It has come to our attention that the iAMP-GM1 may reset when adjusting the power seats in the Camaro. Please follow the steps below to remedy the issue.

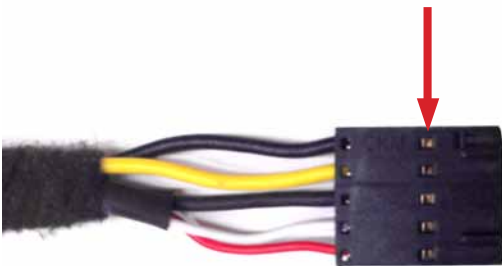
1. Locate the 5-pin plug at the amplifier and disconnect it.

2. Locate the black wire in Pin 1 of the 5-pin plug.

3. Flip the plug over and remove this wire by pressing on the release tab with a straight pick or similar tool.

4. The plug should look like this when finished. Secure the wire with electrical tape and re-connect to the amplifier.

Please Note: If updating the firmware on the iAMP LCD touch screen display becomes necessary, you will either have to re-connect this wire or remove the radio to gain access to the display harness.
